**Inspection Report  
420-426 Pitt Street, Haymarket**

# 420-426 Pitt Street Haymarket

**Council investigation officer Inspection and Recommendation Report**  
**Clause 17(2), Part 8 of Schedule 5, of the Environmental Planning and Assessment**  
**Act 1979 (the Act)**

**Re: INSPECTION REPORT  
MOSAIC  
420 PITT STREET HAYMARKET ("the premises")**

Figure 1 - Example Boost Pressure signage.

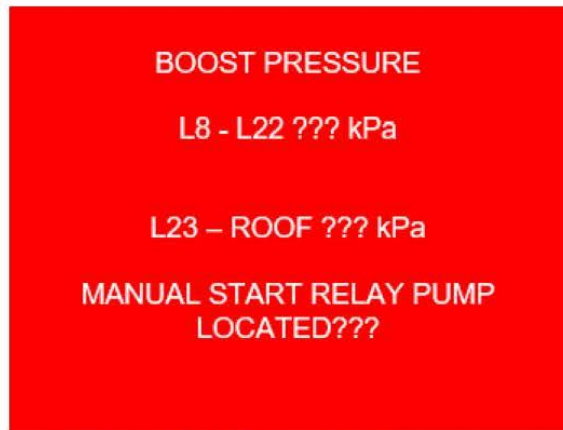
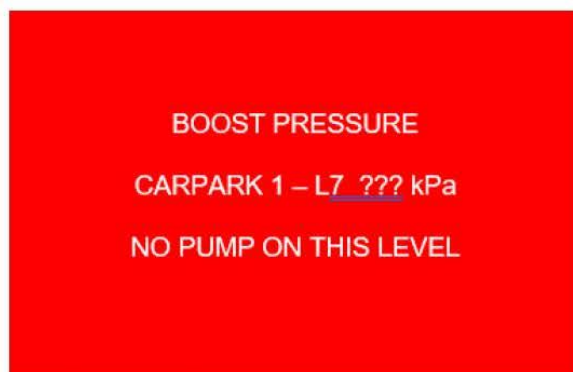
- d. Multiple boost and test pressure signage should be installed at each boost inlet connection for each pressure zone as per Item 1A.B. above. The Zone 2 and 3 boost inlets connection should contain two pressures (see Figures 1 and 2).
